RE: Delete an Authorized User and new department diagram.  
**NRC License No. 21-20250-01**  
**Facility Name - Cheboygan Memorial Hospital**

The purpose of this letter is to notify you of the changes to our current NRC license.

**Item #2.** Please find the enclosed diagram for the remodeling of our facility.

## Camera Room and Control Room

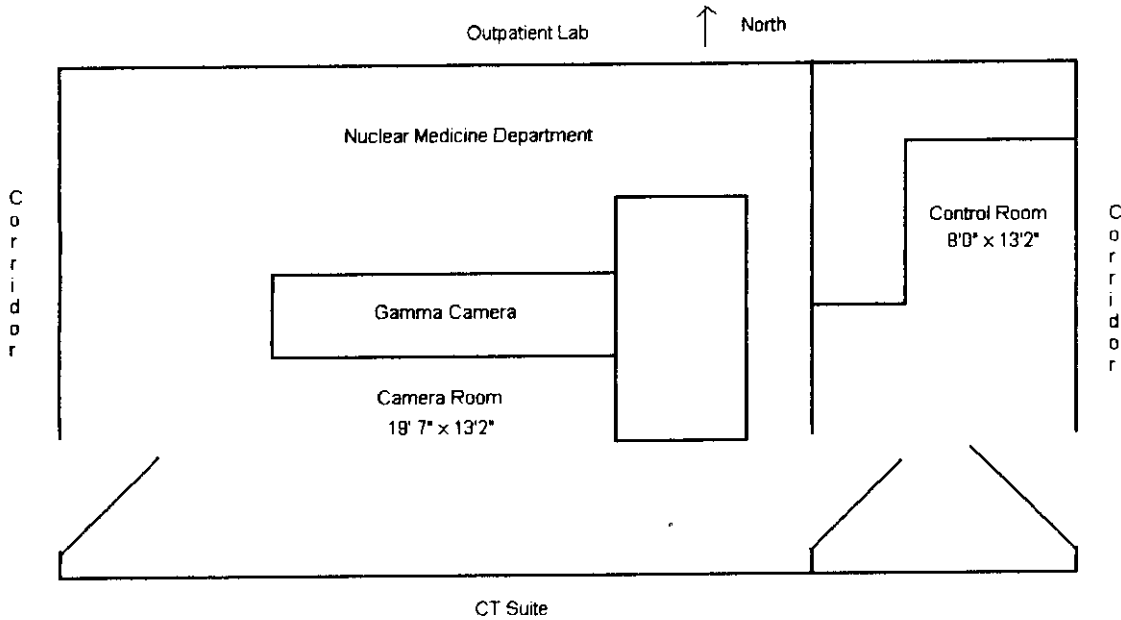
- Please note the north direction and room dimensions listed on the enclosed area diagram.
- The door to the hot lab will be under lock and / or key at all times. Only nuclear medicine technologists and the RSO will have access to the keys and/or combination to the hot lab.
- Please note that the camera room is in a different location within the hospital. The stress lab will move into the current Nuclear Medicine department. Upon receiving your approval for the new area, we will relocate the camera room and the stress lab. Additionally, we will perform the close-out of the current stress lab.
- Please note there are no room numbers throughout the department.
